PLAN AND ZONING COMMISSION MEETING

CITY OF DAVENPORT, IOWA

City of Davenport
Community Planning & Economic Development Department
FINAL STAFF REPORT

Meeting Date: 04-04-17
Request: Final plat: 35 single-family lots and 1 outlot
Address: 4823 Jersey Ridge Road
Case No.: F17-05
Applicant: TW Development Inc

<u>PROJECT</u>	Final Plat Villas at Pheasant Creek 2nd Planned Unit Development Davenport, Iowa	<u>DEVELOPER</u>	TW DEVELOPMENT INC. 6711 Double Eagle Drive Davenport, Iowa 52804	<u>SHEET NO.</u> 1 OF 1
----------------	---	------------------	---	----------------------------------

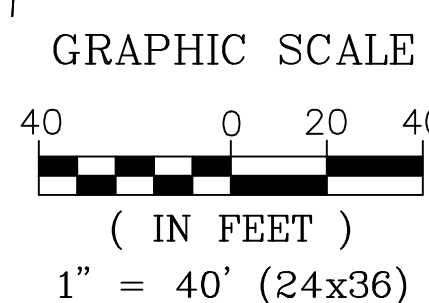
Streets. The subject plat moves north from the first addition in the eastern portion of the development site. Access is from Jersey Ridge Road (an arterial street) through the First Addition. Whereas the preliminary plat proposed access to Jersey Ridge Road north of the Baptist church as well as the existing south access, this Second Addition appears to remove that access option and loops Pheasant Creek Avenue back to the south access. Since this appears to be a loop or circular street both sides of the street will need to be named differently for addressing purposes and public safety.

Also, since the developer is not continuing the street along the north to connect with Jersey Ridge either a cul-de-sac of some sort or panhandle lots for lots 1 and 2 with a private drive access to the homes will need to be created. The City would prefer the panhandle lot scenario. An easement for access to the drainage easement within the panhandle(s) will need to be dedicated.

Per Section 13.34.270 the Natural Resources Division must review plans and calculations prior to final plat approval with subdivisions. This determines whether the developer has fully developed their detention and quality requirements in which easements are shown on the plat. There will need to be a dedicated outlot reserved for stormwater detention

as was included in the 1st Addition final plat. It cannot be located within the 100-year floodplain or storm limits of Hanlin's Creek.

Also filling on sanitary sewer easements is not allowed, this may cause a problem with how the developer will fit the detention in the remaining area of the drainage easement that is between the sanitary easement and the lot lines.

Twenty (20) feet of Lots 29 through 35 is located in the drainage easement. This drainage easement abuts the buildable area of these lots. Lots abutting this easement will need to have their lowest floor, including basement, one (1) foot above the 100-year flood (storm) elevation for Hanlin's Creek.

The drainage easement contains a note that the area of the drainage easement is at or below the overflow elevation at Lorton Avenue. This "overflow elevation" may not be the 100-year storm/flood elevation for Hanlin's Creek. The 100-year storm/flood elevation will need to be determined for this segment of Hanlin's Creek. Otherwise the City accepting a lower elevation puts people's lives and investments at risk.

I would like to see what the north roadway area will look like prior to approval for roadway design. I am questioning the area in front of lots 1-3 with only a 25 foot right of way for public?

Also the drainage area is to me in question as to how it could detain in this area but still be part of the creek? The overflow elevation at Lorton does not mean the 100 year flow elevation. That elevation could be higher?

Easements containing public sewer should be dedicated as "sewer" easements rather than being incorporated in a utility easement. We need to review and approve the construction plans for streets and sewers prior to approval of the plat. I also concur that we should not accept a 25' ROW and "dead end" street at lots 1&2.

We will need to see a dedicated outlot reserved for stormwater detention as was included in the 1st Addition final plat. Per Section 13.34.270 we are supposed to be able to see plans and calcs prior to final plat approval with subdivisions. This would help us determine if they have fully developed their detention and quality requirements in which easements are shown on the plat. That being said, as filling on sanitary sewer easements is not allowed, I am unsure how they will fit their detention in the remaining area of the drainage easement that is between the sanitary easement and the lot lines. Minimum low water entry elevations should be provided for any lots that abut a detention area or drainage easement.

1. Construction plans for streets and sewers will need to be reviewed and approved prior to the plat being submitted to City Council;
2. Plans for grading, erosion control, detention and infiltration along with supporting calculations will need to be submitted and approved prior to the plat being submitted to City Council;
